$_{\text{MODEL}}$ 2101 - version -13 jungle

SPIKE INNER - OUTER

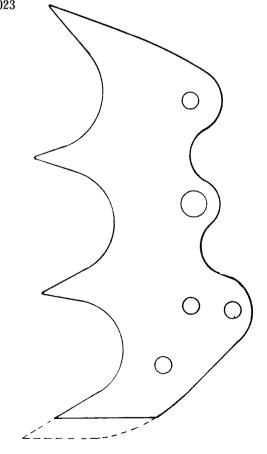
One more version for hardwood is introduced. The bottom tooth is shortened and moved upwards. See illustration.

This modification prevents the saw from getting stuck in the cut and clutch slippage.

The spikes are marked with "J".

Note! It is only valid for version -13 jungle.
